Reference: 0418291

Subject: Sancrox Quarry Expansion: EPA Advice on Response to Submissions Report – Air quality

The NSW Environment Protection Authority (EPA) have reviewed the Submissions Report for the proposed Sancrox Quarry Expansion Project (Application SSD-7293). Recommendations for further analysis or explanation were provided to the Department of Planning, Industry and Environment (DPIE) on 22 June 2021, and some of these related to the Air Quality assessment. This letter summarises those comments and EPA recommendations, and provides a response for each.

Figure 2: Cumulative annual average TSP concentrations for throughput of 530,000 t/y

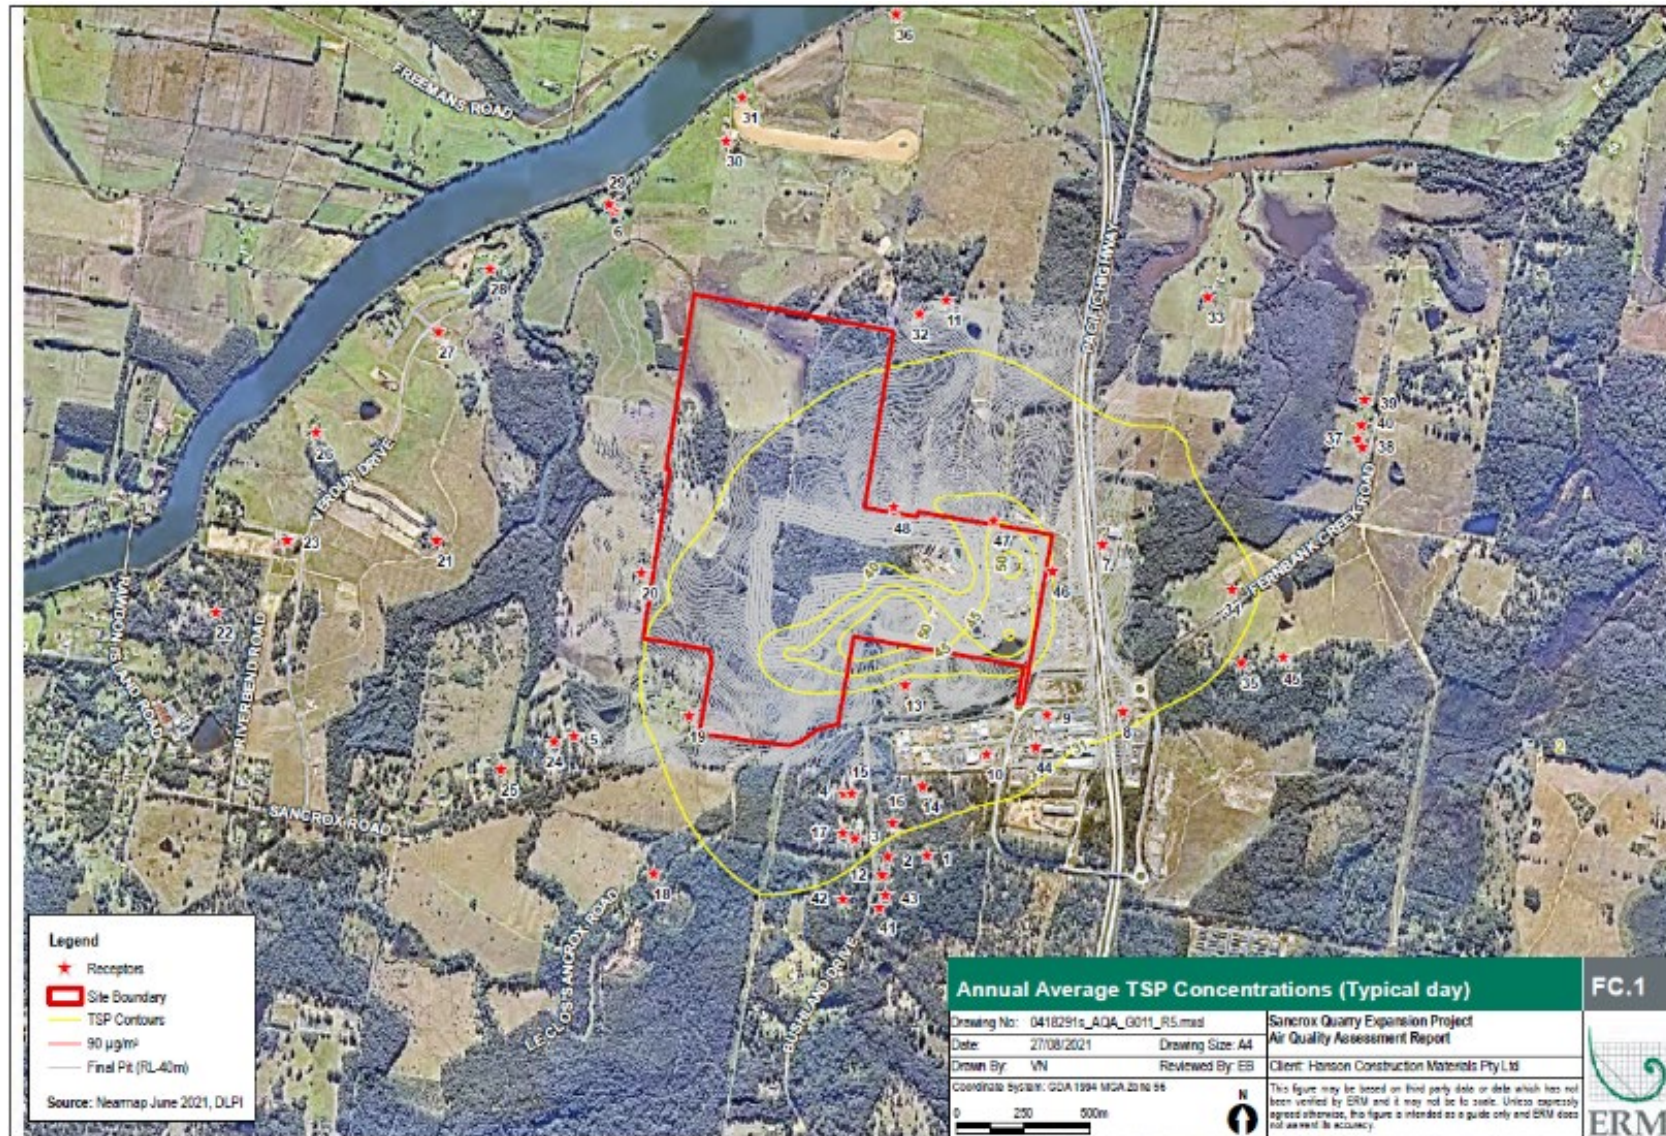
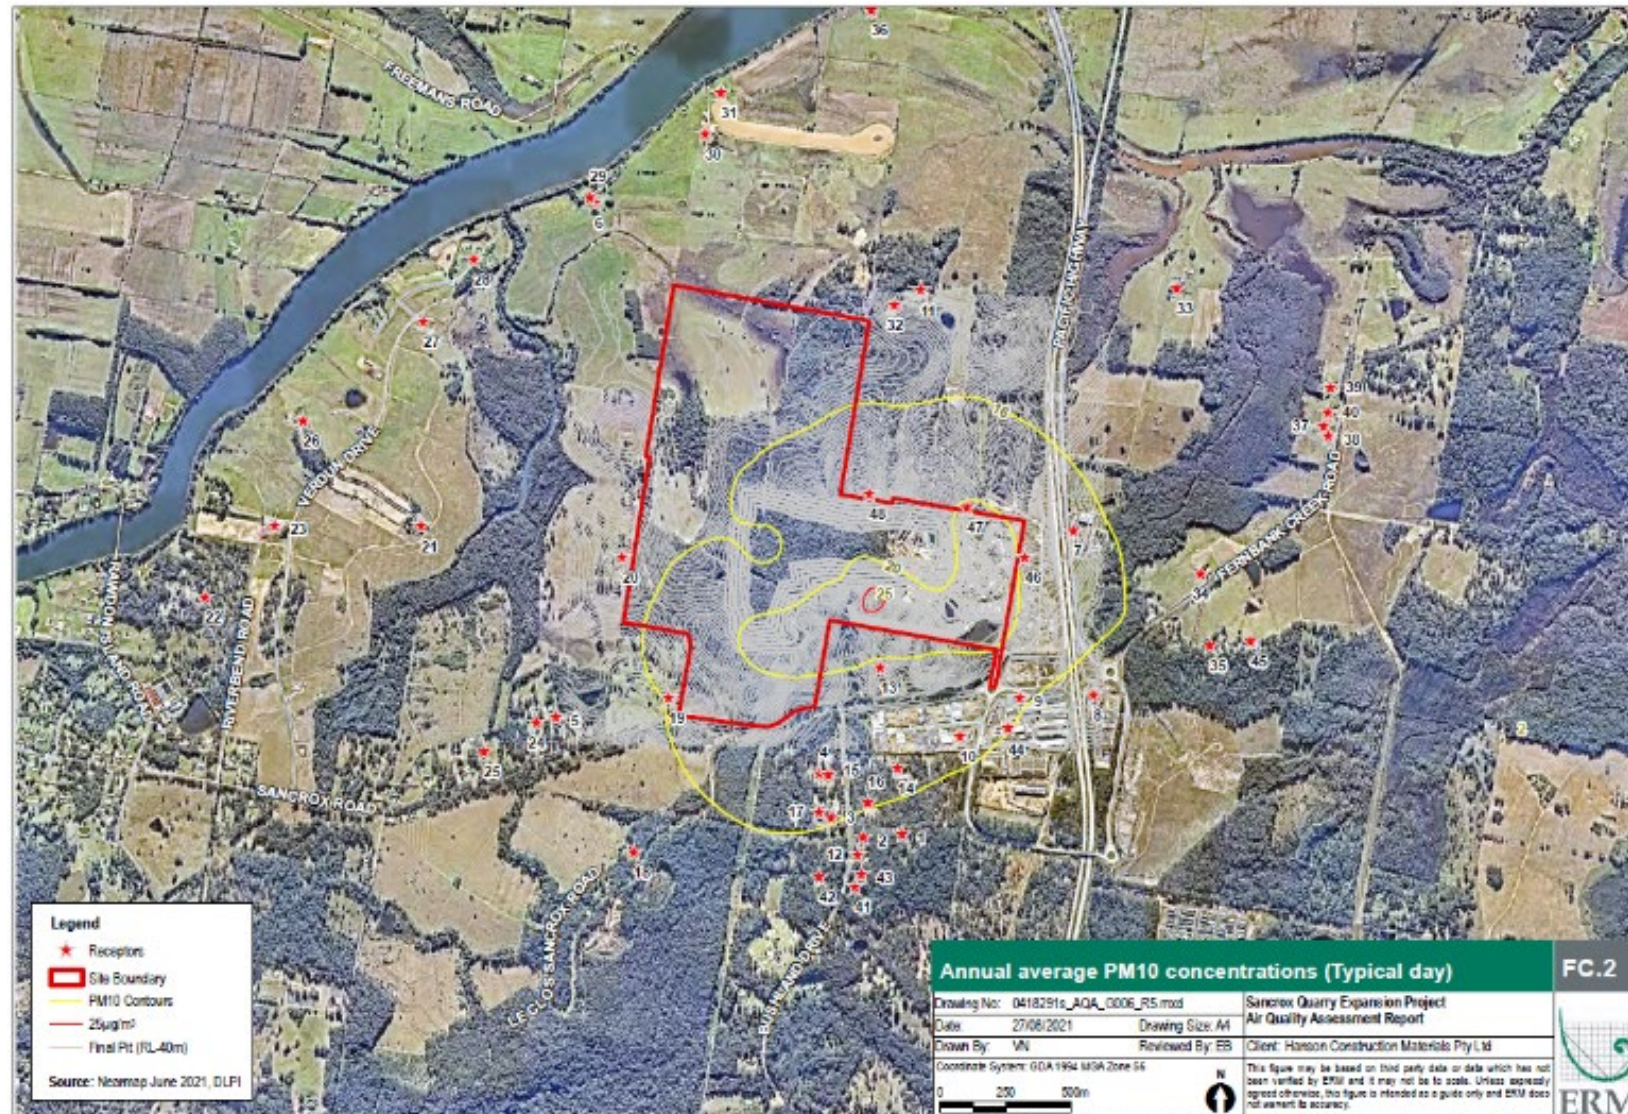
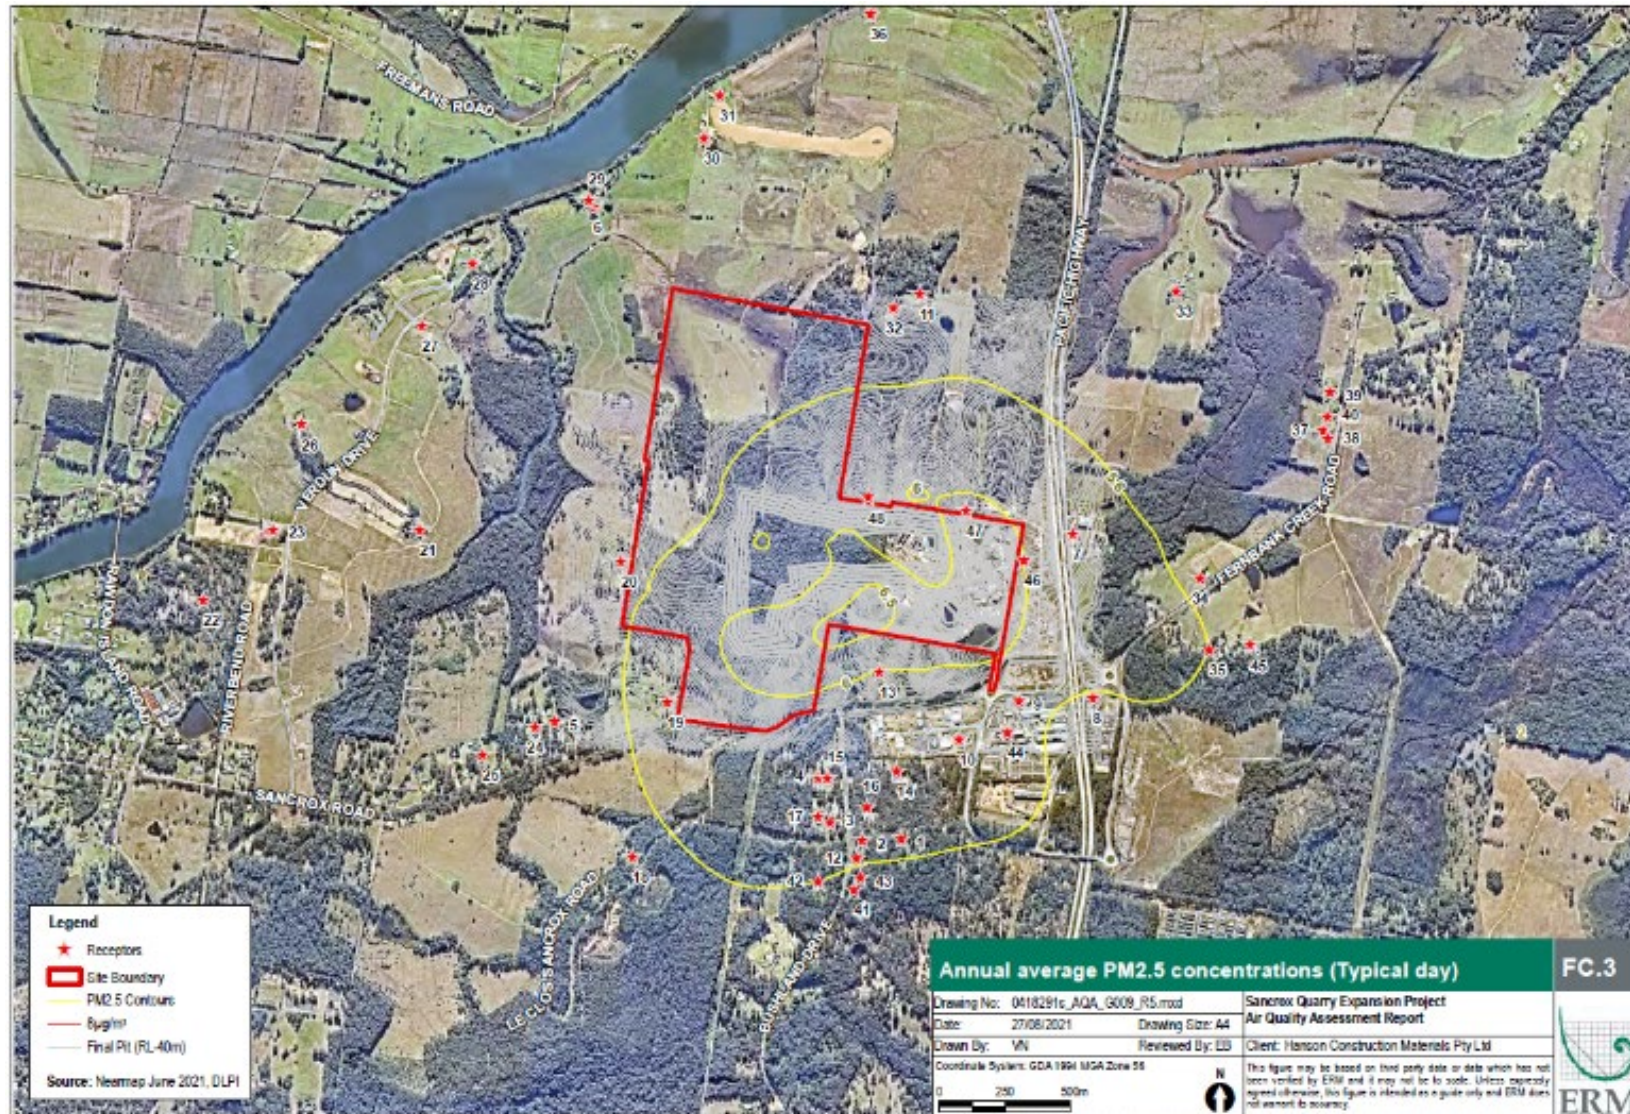
Additionally, the contour plots should be reviewed and revised where appropriate, given the discrepancies with tabulated results.

Updated contour plots for annual average predicted TSP, PM₁₀ and PM_{2.5} concentrations are provided in Figure 2, Figure 3 and Figure 4, respectively. These plots represent the predicted cumulative impact, including both the Project increment and background. It can be seen that there are no predicted exceedances of the EPA assessment criteria at any of receptors assessed.

Figure 5: Cumulative 24-hour average PM_{10} concentrations at R47 for throughput of 530,000 t/y

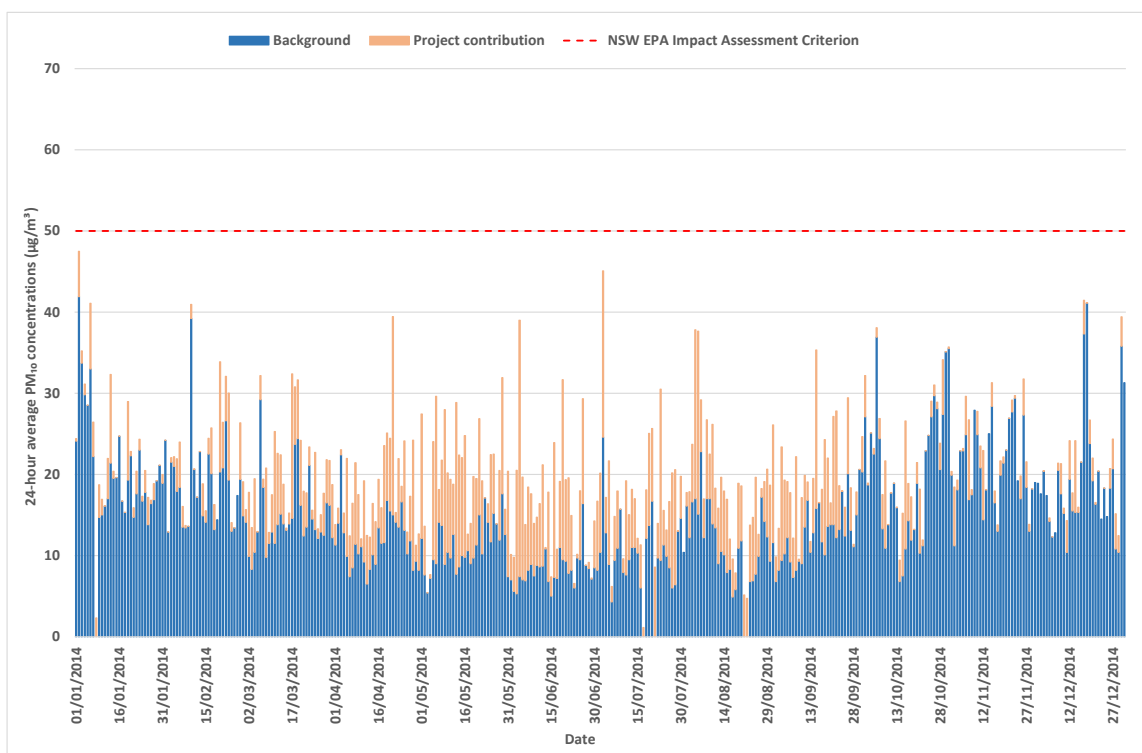
Further, and whilst it is acknowledged that no additional exceedances are predicted for the 'Maximum day (5am – 10pm)' emissions scenario, additional information is required to allow for a robust and transparent review of the assumptions made and input data used to estimate emissions for this emissions scenario.

Additional analysis of the typical throughputs on a daily basis throughout the year, shows that the maximum 24-hour average PM_{10} criterion is not expected to be exceeded at the nearest sensitive receptors. Figure 5 shows the combined background (blue) and project contributions (orange) to the total cumulative PM_{10} concentrations for each day at R47. This plot also shows that the higher background concentrations generally do not occur at the same time as higher project contributions.

Figure 6: Project increment maximum 24-hour average PM_{10} concentrations for maximum daily throughput (normal operating hours)

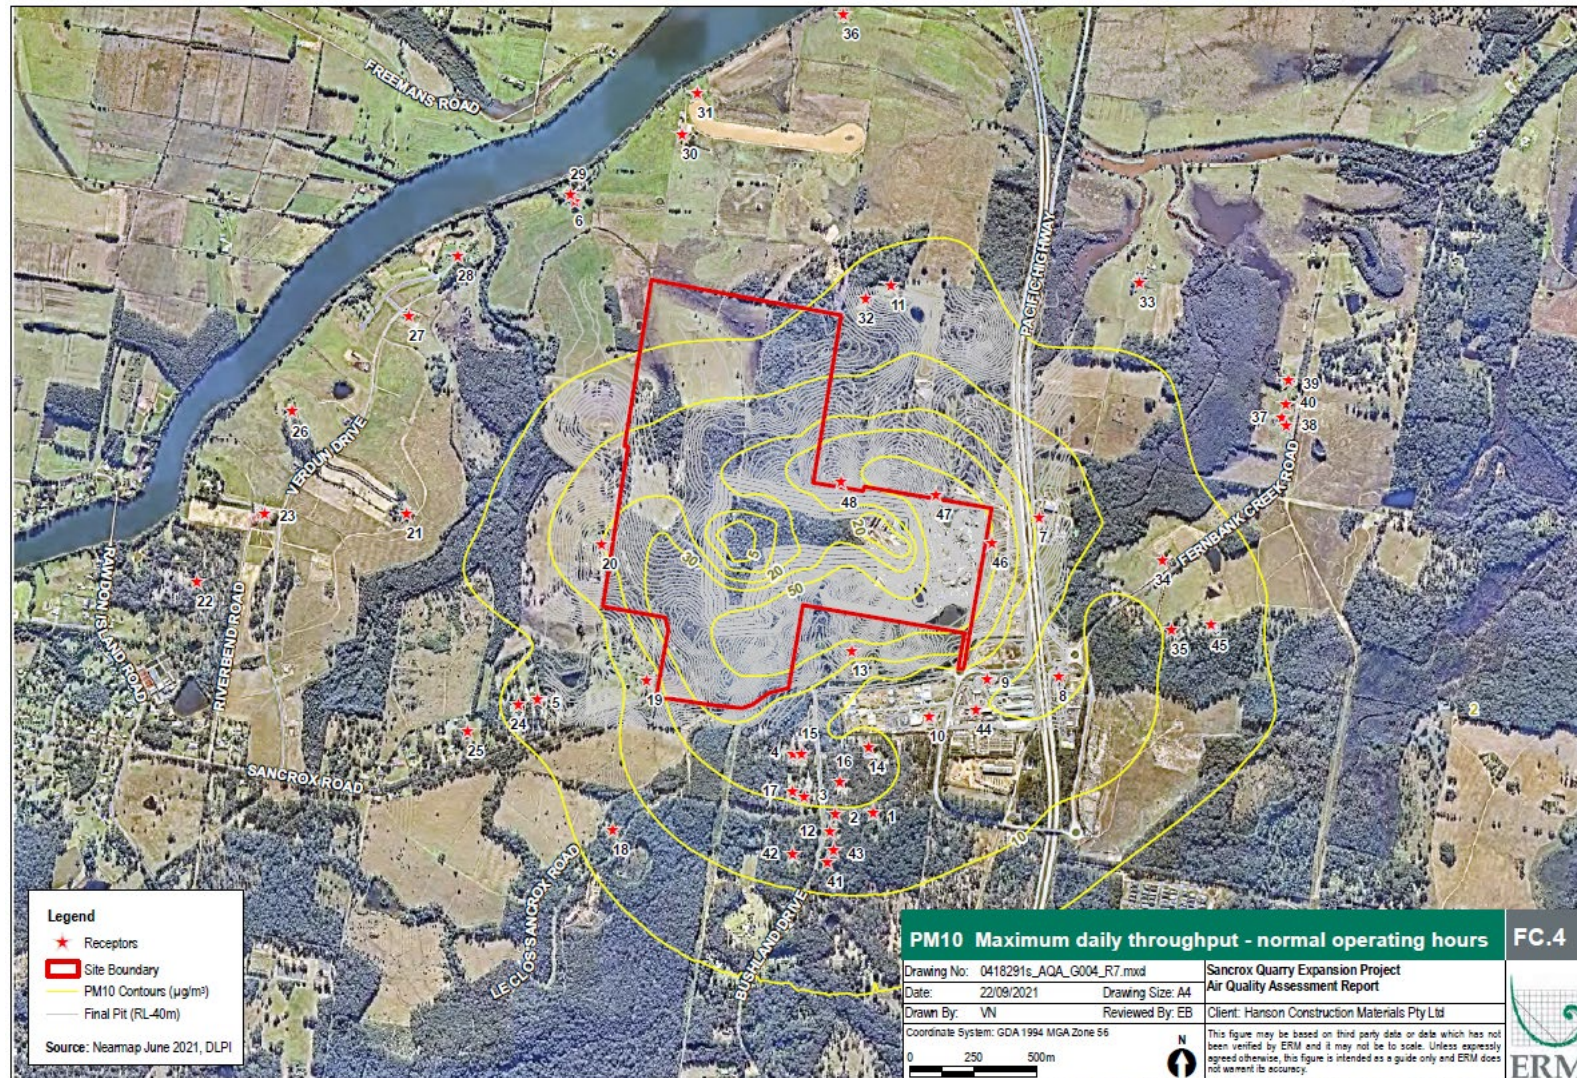
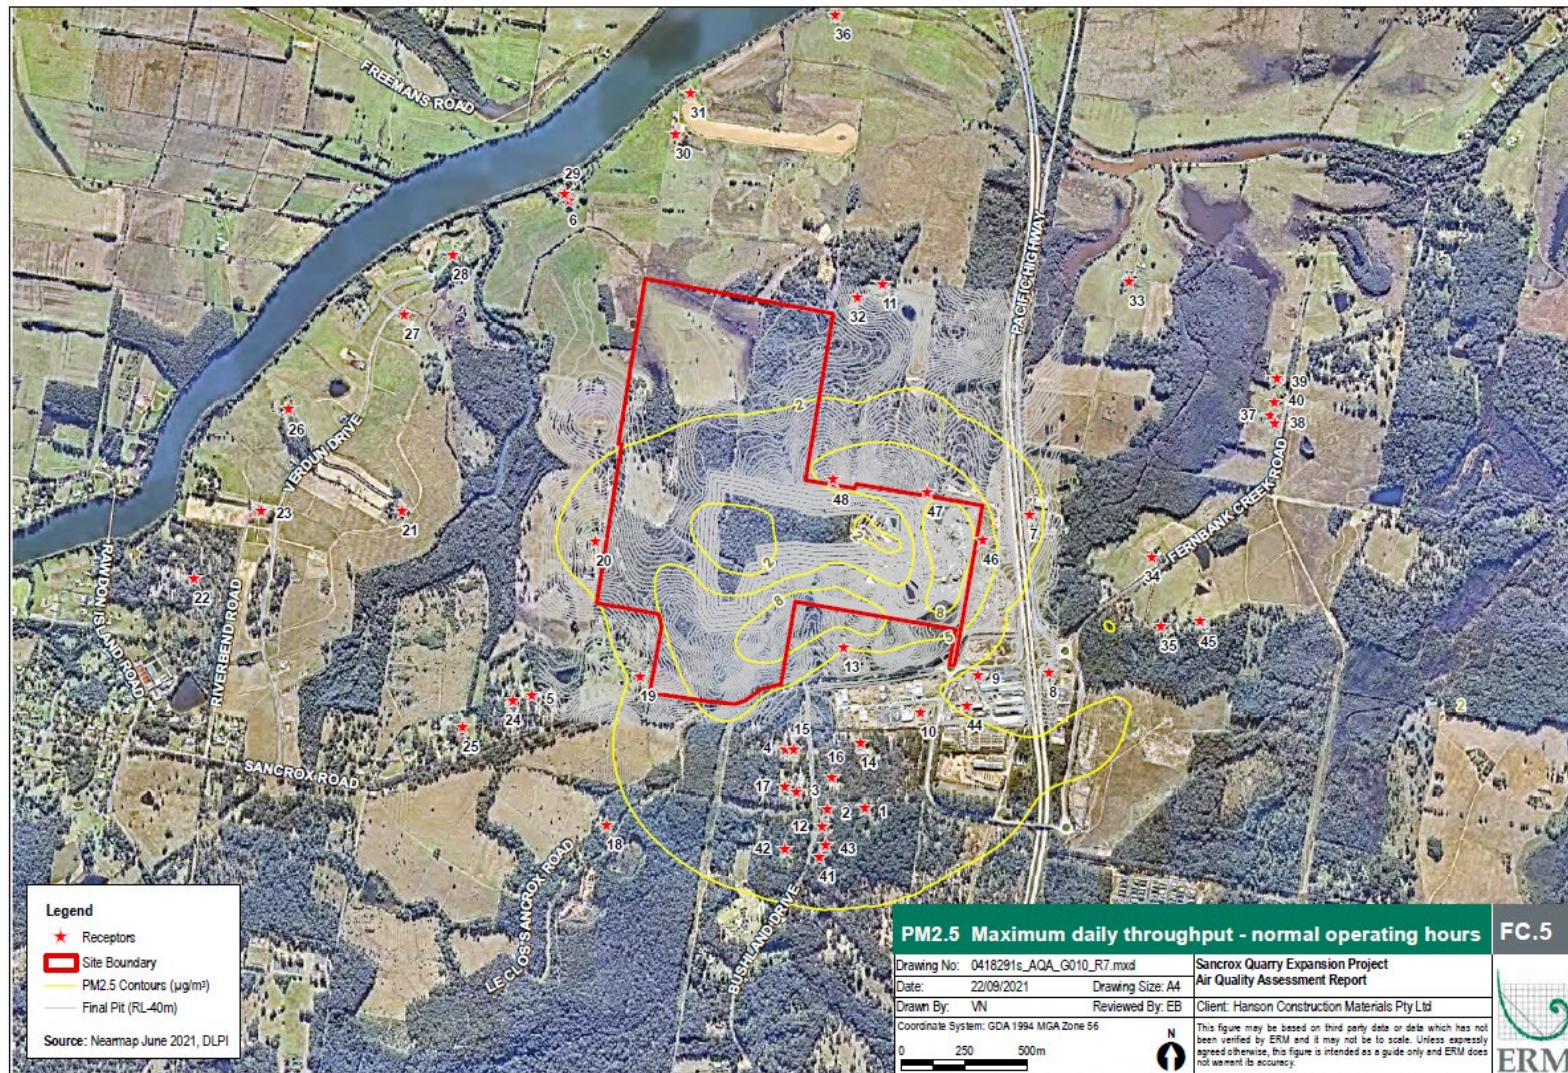
1 Additional exceedances of the EPA's 24-hour PM₁₀ criterion are predicted at receptor R13.

Given that it is proposed that operations may be undertaken for 24 hours during 20 days a year, a 'Maximum Day (24 hours)' emissions scenario was prepared to show the potential impacts of the 24-hour on-site operations at the maximum daily proposed throughput. Results for this emissions scenario, show that there are 3 predicted additional exceedances of the EPA's 24-hr PM₁₀ criterion at receptor R13.

The values for the individual sensitive receptors are presented in Table 3, showing the cumulative PM₁₀ concentrations, together with the Project increment on that day. The results show the predicted exceedances at receptors R46, R47 and R48. The final column shows the largest Project contribution (no background concentration), and shows that for all receptors except R46, R47 and R48, the Project contributions are moderate to low. Updated contour plots for maximum 24-hour average PM₁₀ and PM_{2.5}² are provided in Figure 6 and Figure 7. These plots show the project contribution only, noting high contributions at R46, R47 and R48.
